ADDENDUM NO. 02

COLTON MIDDLE SCHOOL – INTERIM HOUSING

DSA #04-124403

RCA Project No. 1-15-118

1 **TECHNOLOGY - ENLARGED SITE PARKING LOT - REMODEL**
1/8" = 1'-0"

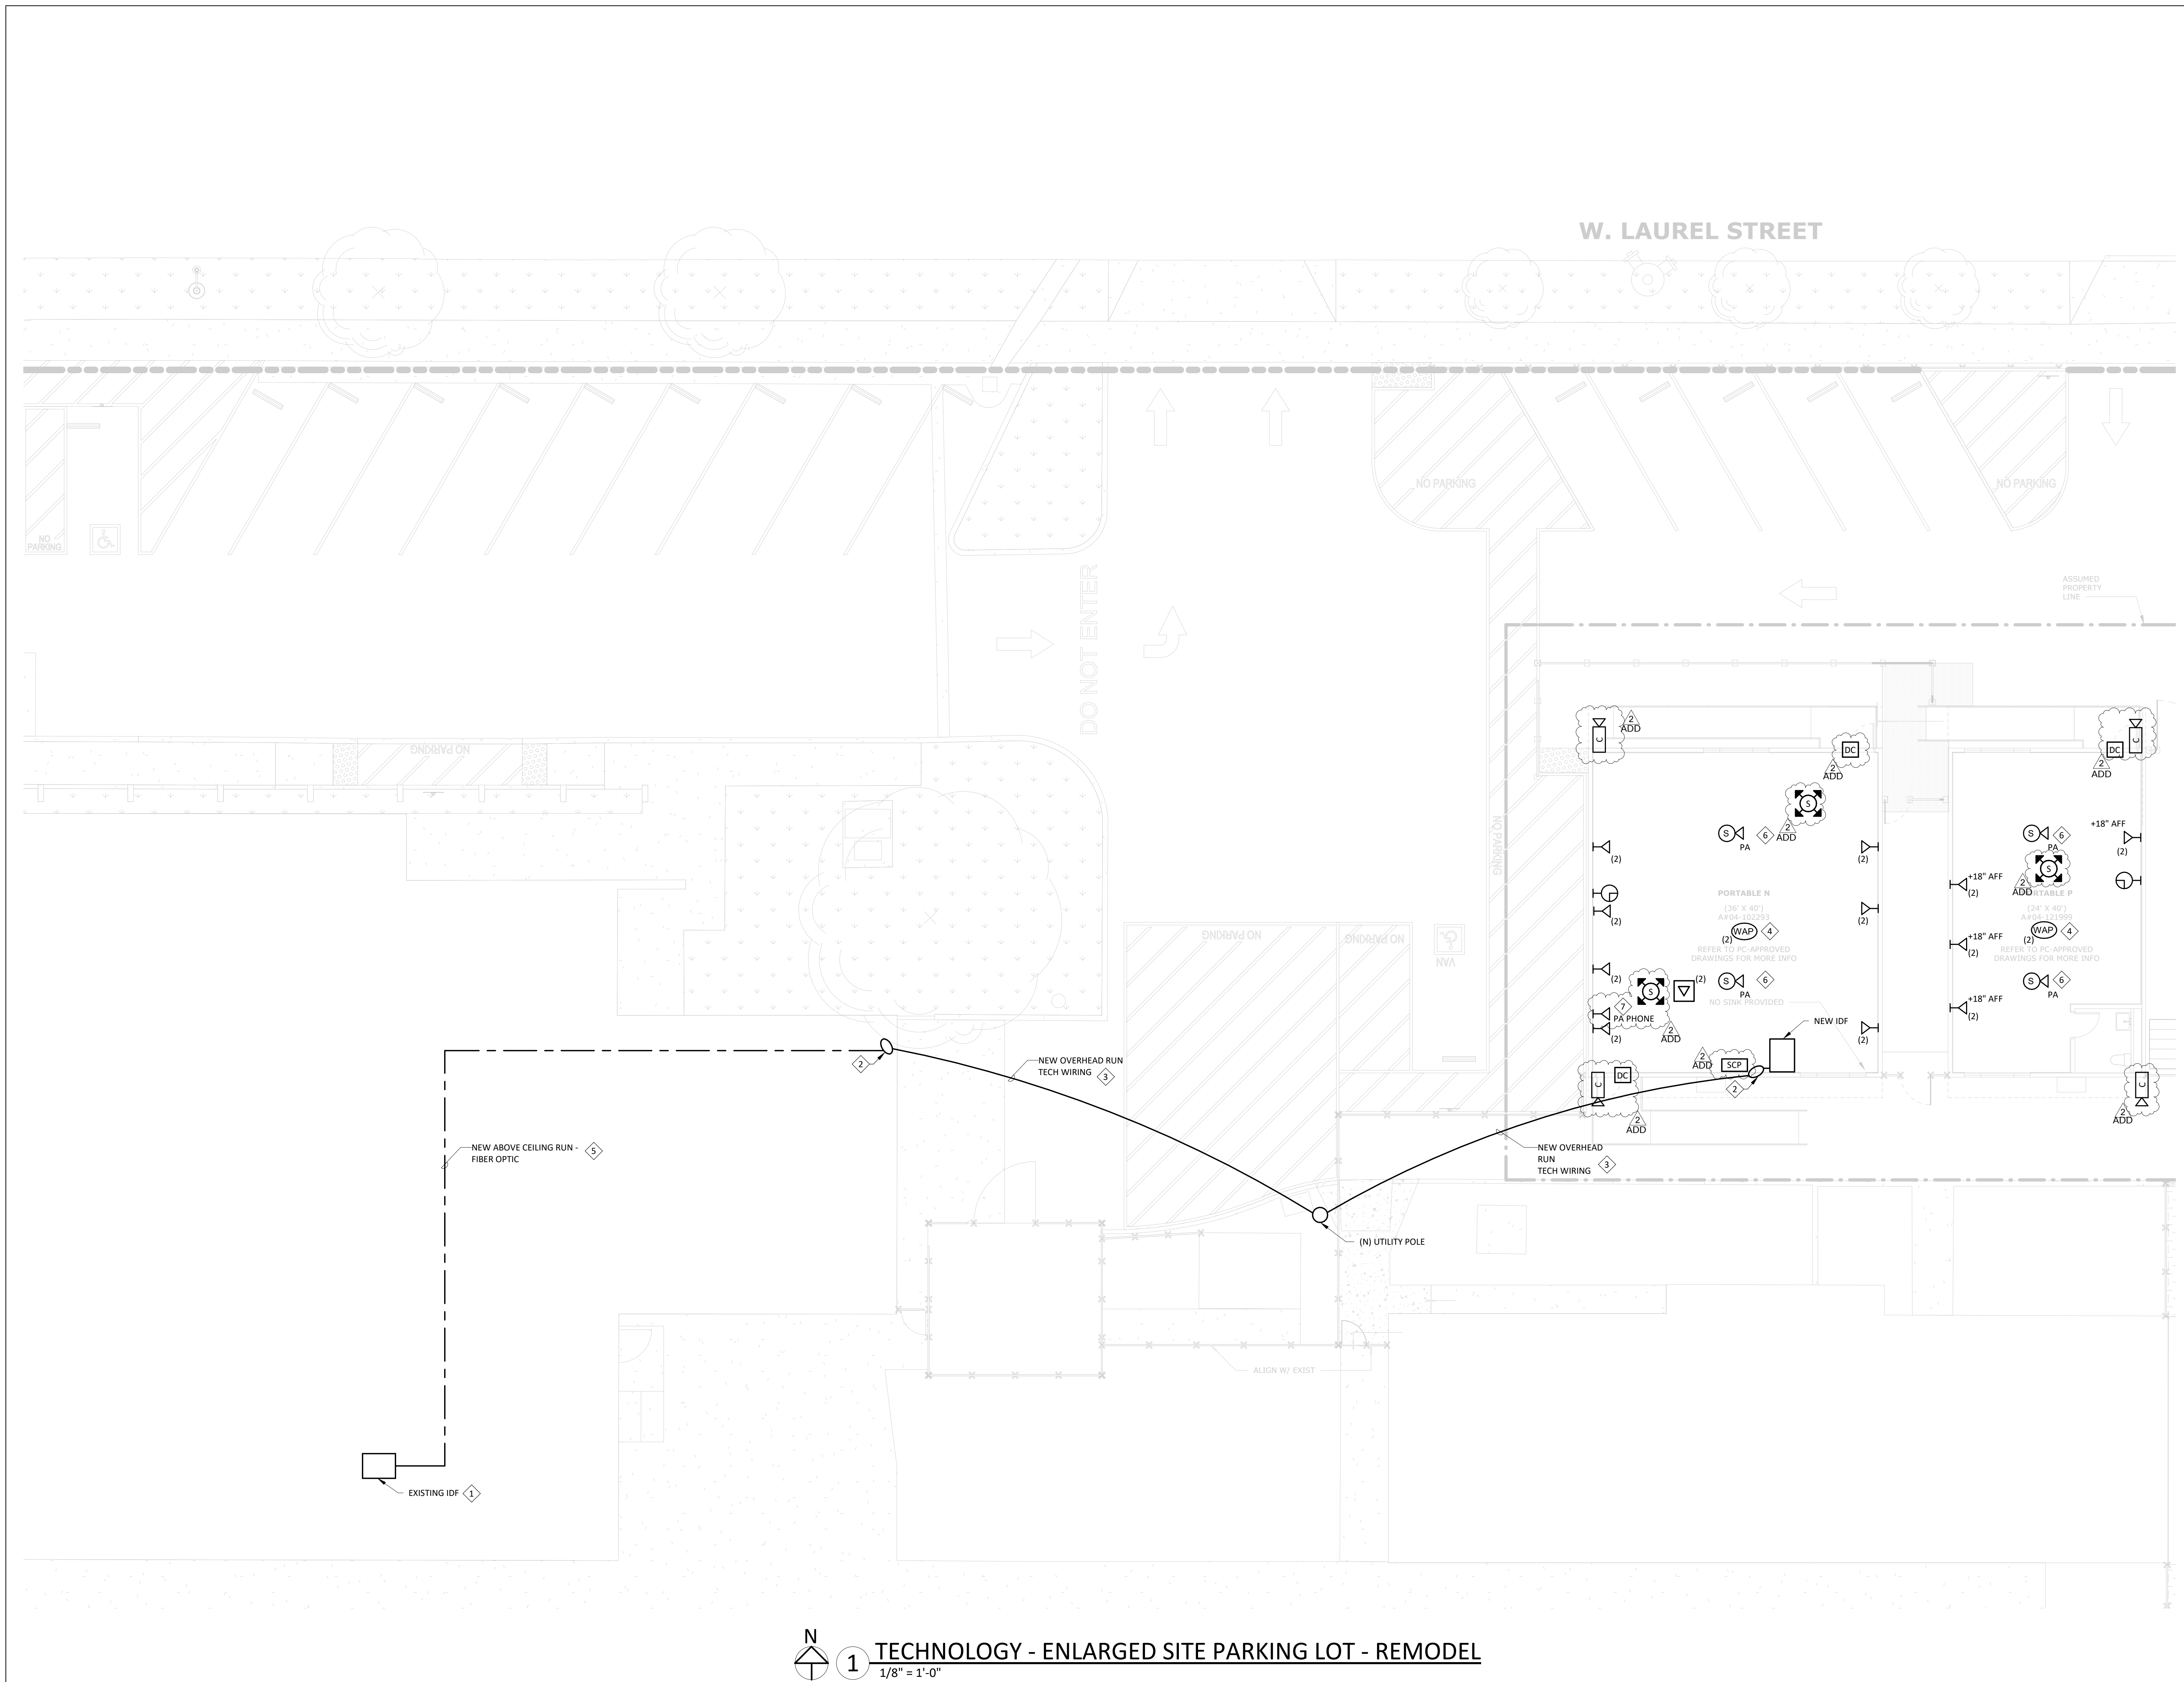
- Item No. 2.8 Reference Sheet TS-1.1– Technology Details
2.8.1 Revise per clouded areas of attached sheet and items listed below
a) Revised data outlet layout to match workstation layout.

b) Added floor data outlet for island workstation.
- Item No. 2.9 Reference Sheet T-4.0 – Technology Details
2.9.1 Revise per clouded areas of attached sheet and items listed below
